**Agenda Item B.1**  
**CONCEPTUAL/PRELIMINARY/FINAL REVIEW**  
**Meeting Date: May 12, 2026**

**SUBJECT:** 6466 Hollister Ave (APN 073-070-035) Wheels In Motion As-built Signage and California Environmental Quality Act Notice of Exemption Case Nos. 25-0031-ZC, 25-0032-DRB

**Attachment A**  
**Preliminary Design Review and California Environmental Quality Action for**  
**Wheels In Motion As-built Signage**  
**Case No. 25-0032-DRB, 25-0031-ZC**

FRONT ELEVATION  
NORTH FACING SIDE  
SCALE 1/12" = 1'

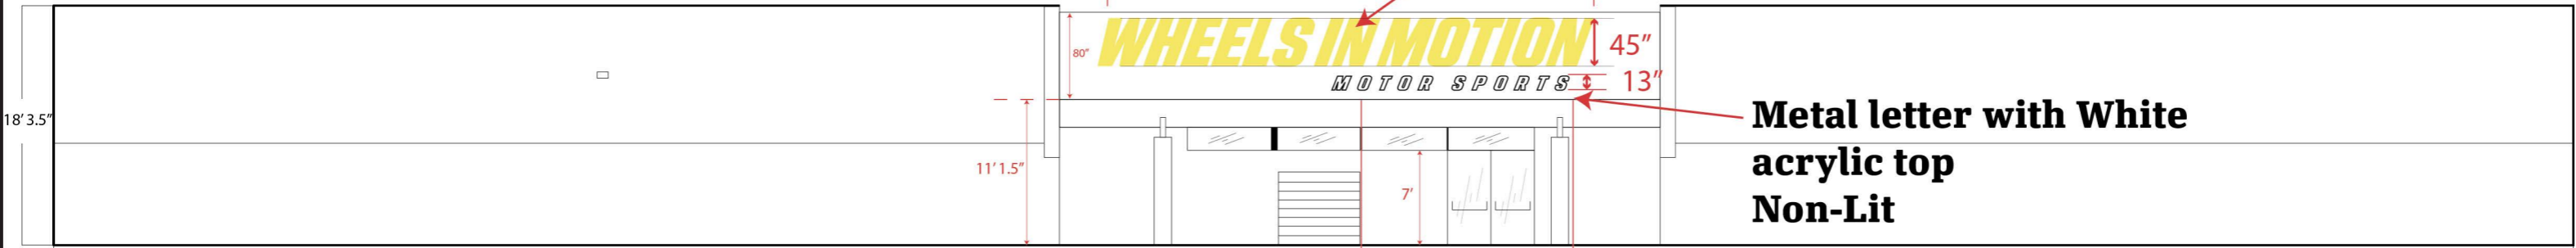
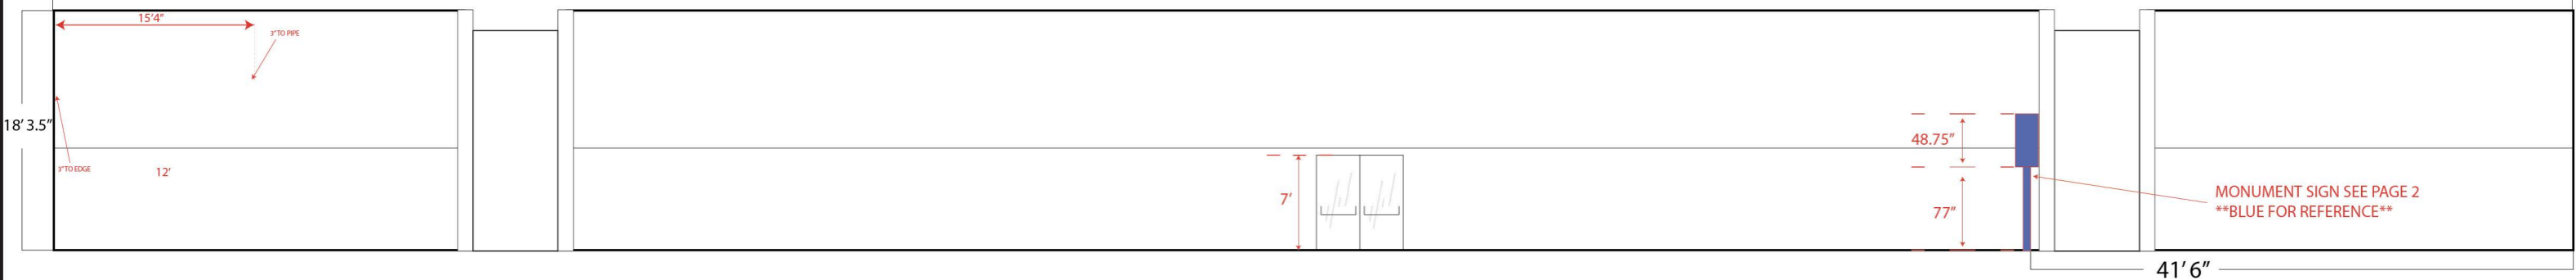
Section 17.40.080(F)2 states: Wall signs may be located up to, but must not exceed, the height of the wall to which they are attached. Since the proposed wall sign does not exceed the height of the wall to which it is attached, the sign complies with the applicable code section referenced above.

*The as-built non-illuminated signs are proportionate to the size of the building and comply with the requirements described in Section 17.40.080(F) which include number of signs, height, size, and projection allotment. However, DRB will need to determine if the proposed sign color palette is compatible. The existing legal non-conforming freestanding pole/monument sign does not comply with the height requirements of Title 17 but was approved by the County prior to incorporation.*
